Case No. 2023-00246
Dogwood Corners LLC
Response to Staff's First Request for Information

STAFF DR 1-1:

STAFF DR 1-30:

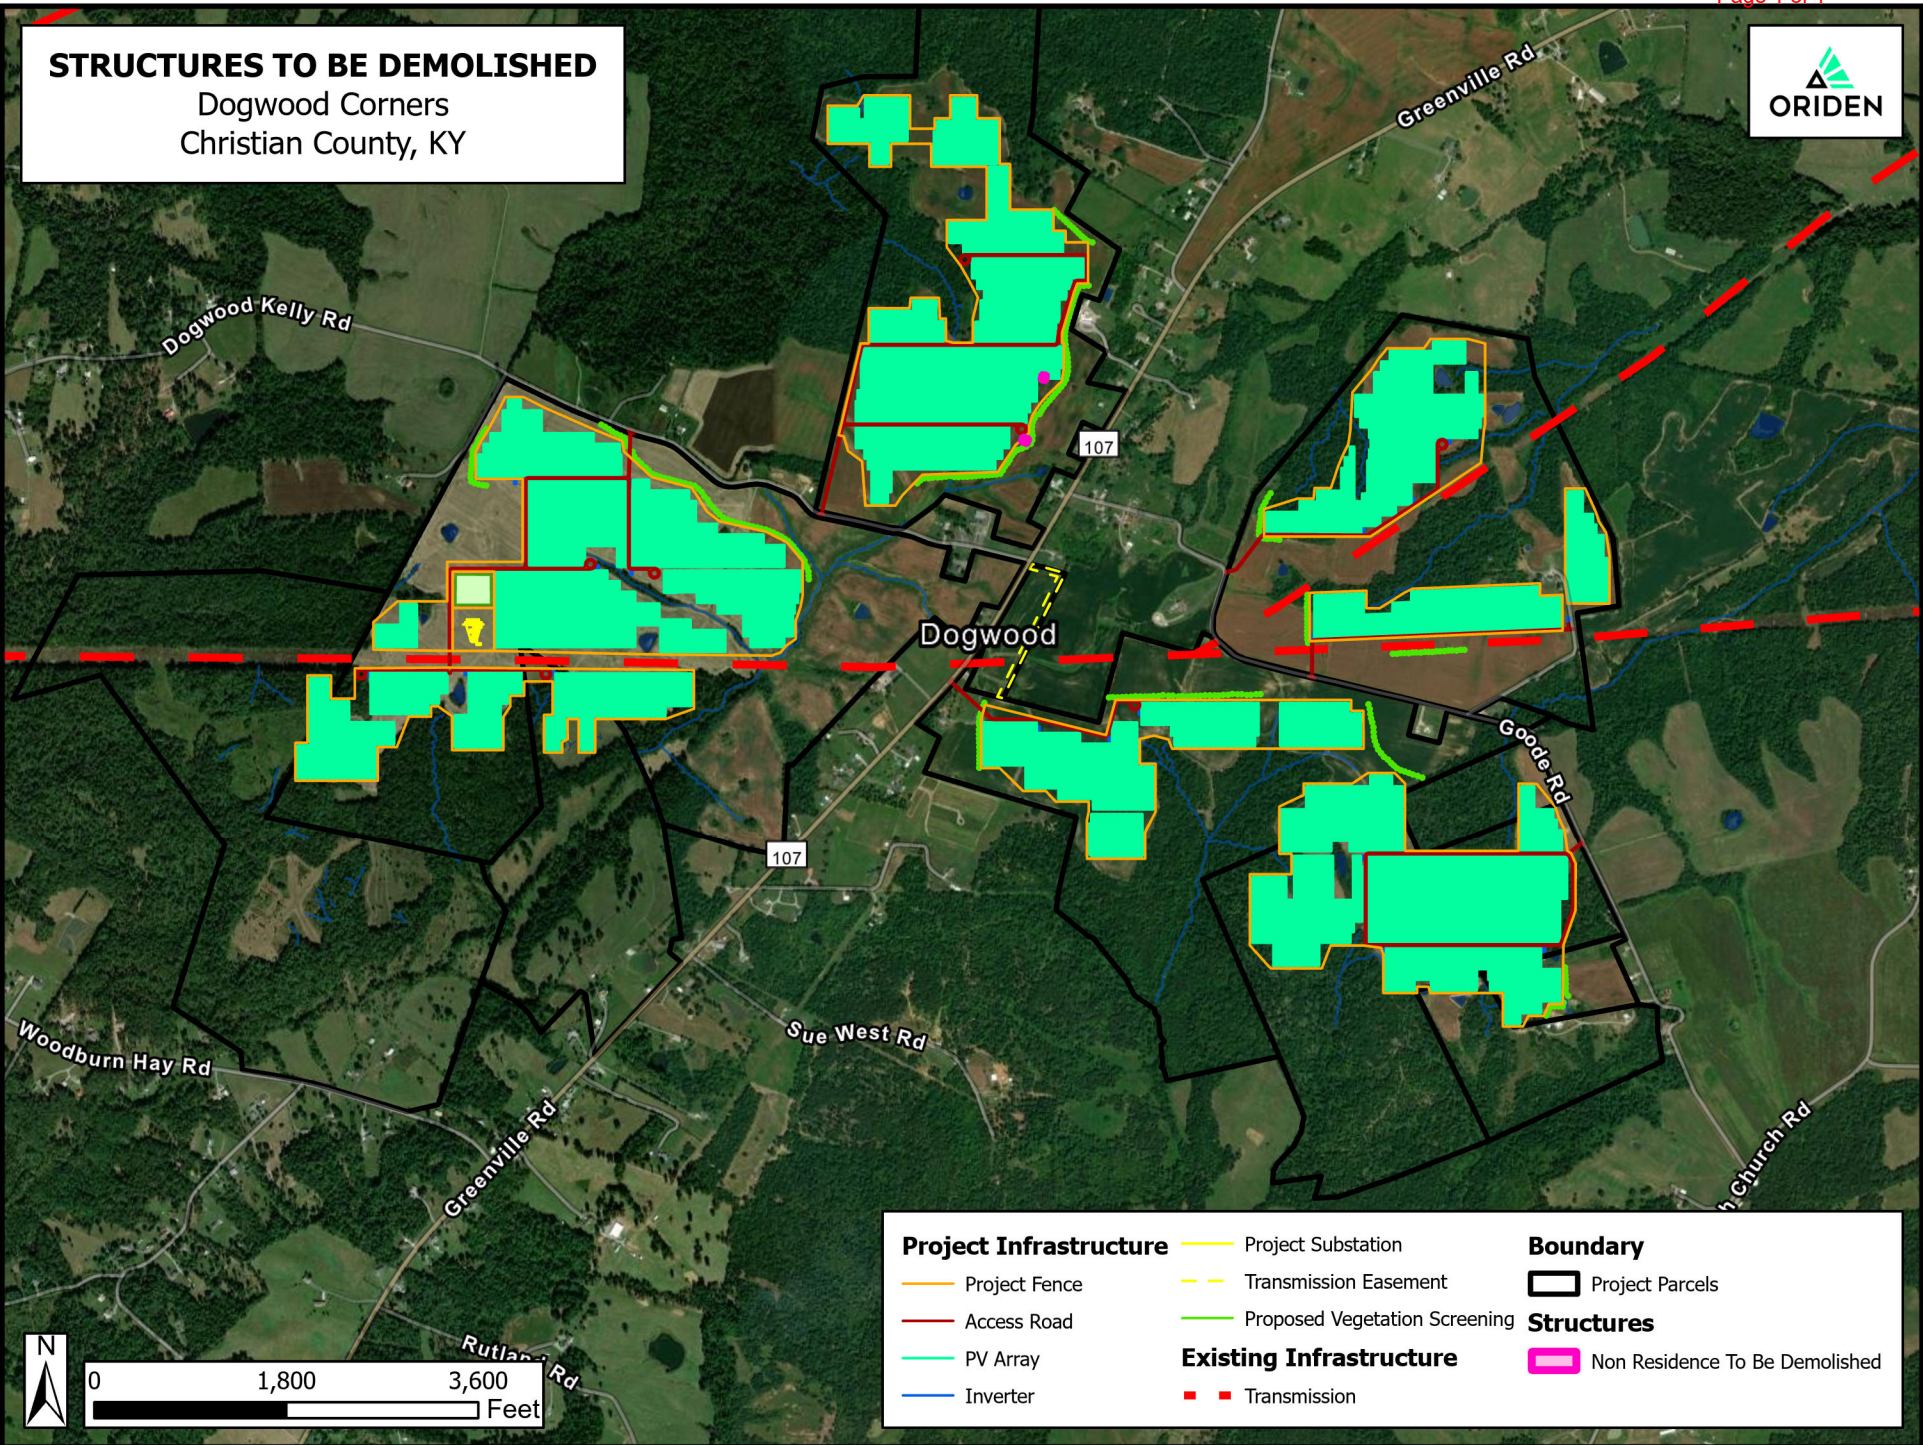
Explain if any existing structures on a parcel of land leased by Dogwood Corners will be demolished or removed during construction.

STAFF DR 1-39:

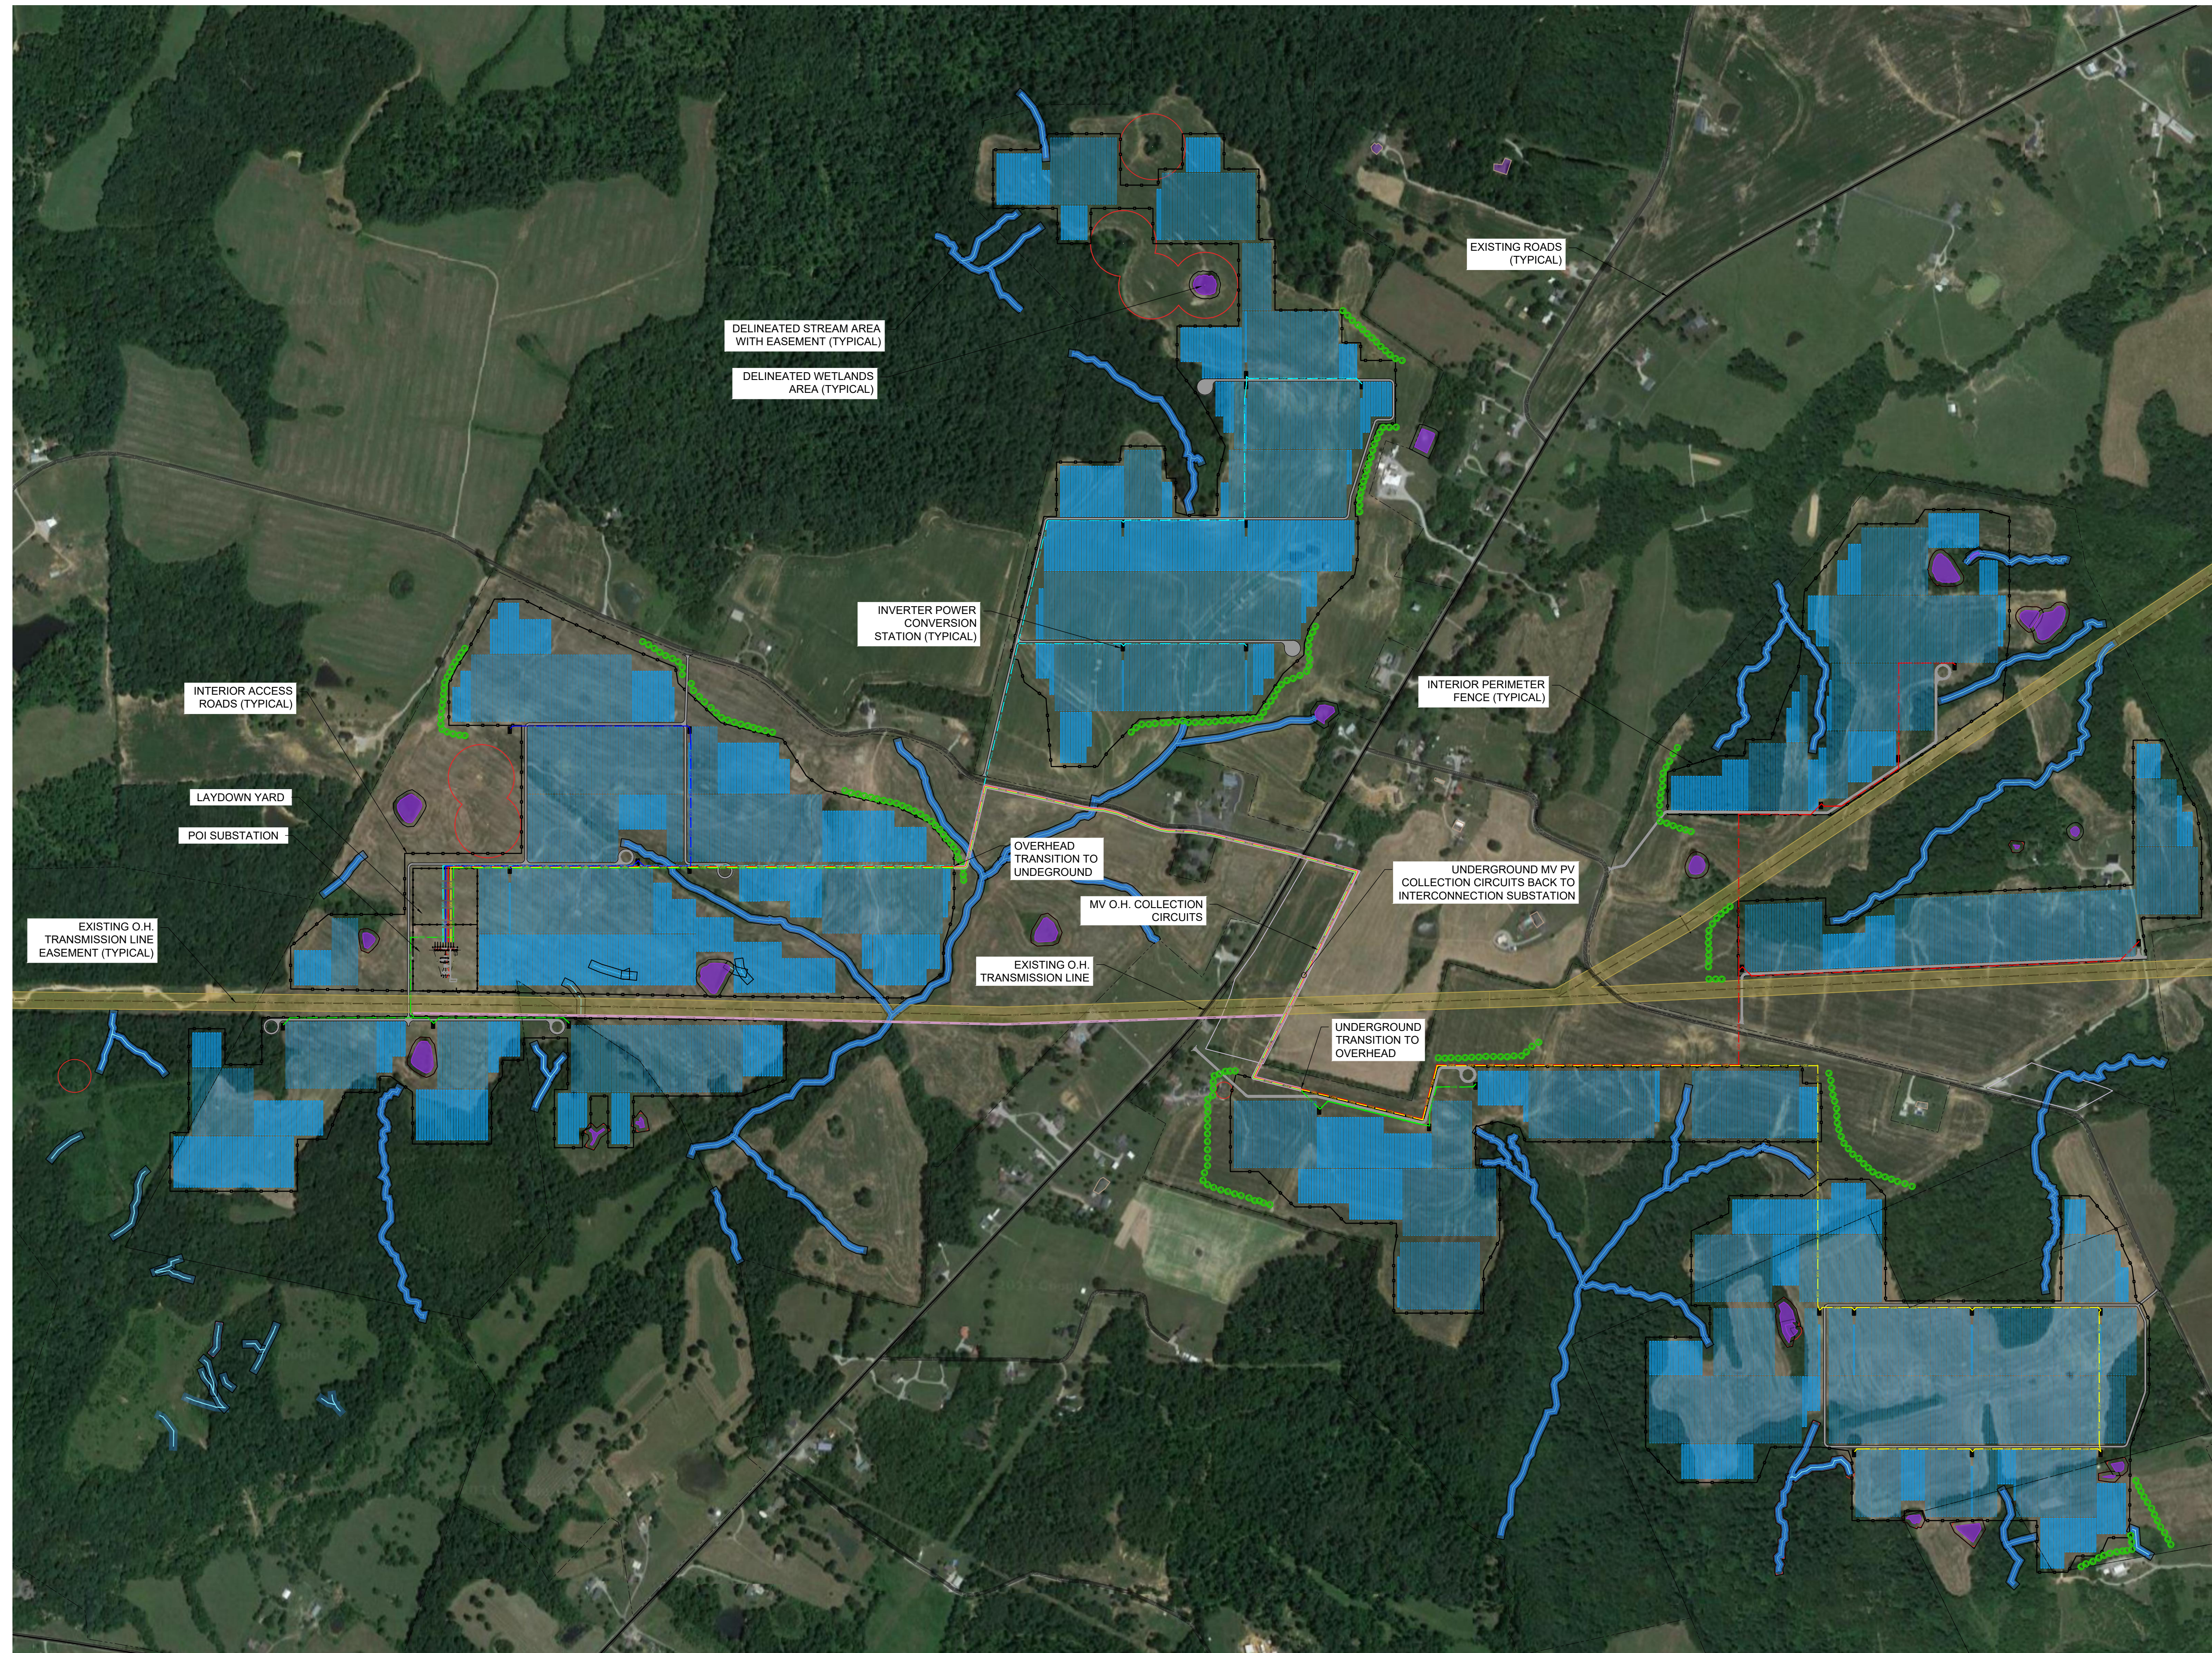
Refer to SAR, Appendix B, Preliminary Site Layout.
